Planning Proposal for Cooks Cove

Subject: Response to Submissions - Cooks Cove Planning Proposal PP-2022-1748

**Request for Agency Response on Cooks Cove Planning Proposal
PP-2022-1748 - 13-19A Marsh Street, Arncliffe**

Appendix A – Bayside Council’s Review of Revised draft Planning Proposal

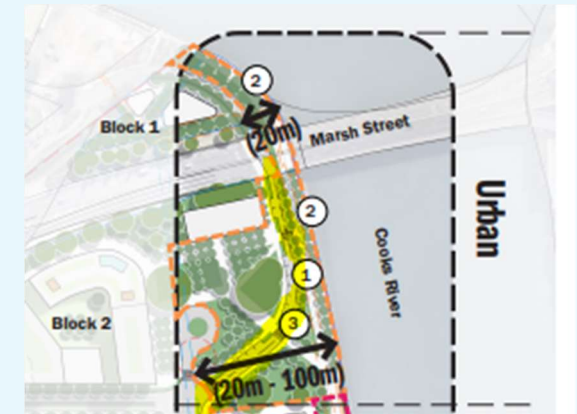
Council raises concern with respect to safety of users along this long stretch of public domain without options for alternative routes and a fear of entrapment. Direct connectivity and passive supervision from the adjacent built form is imperative to avoid creating unsafe spaces, especially for pedestrians. A high standard of lighting and aesthetic treatment to ensure a high level of activation is also vital.

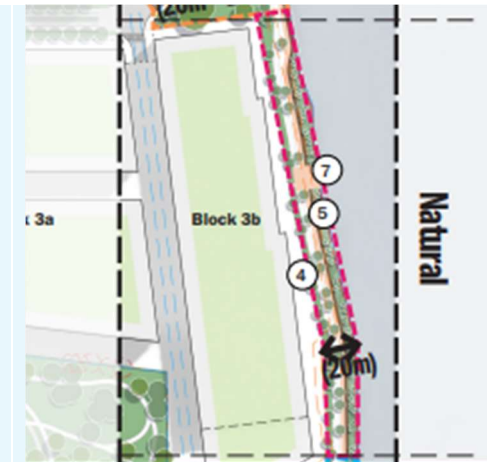
- Urban Zone: It is maintained that 20m-100m will be provided, however this includes a 7m wide road that separates the public use and private landscaping associated with the hotel.

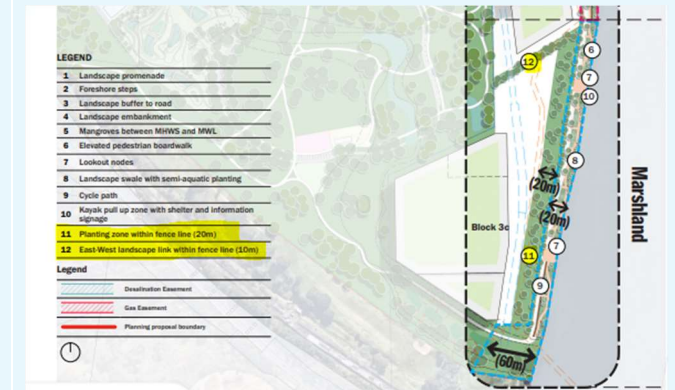
- Natural Zone: In the northern section of the foreshore area there is approximately 300m of foreshore that remains only 20m wide. This includes areas with establishing mangroves that will ultimately reduce visual openness. This is also a risk to CPTED principles.
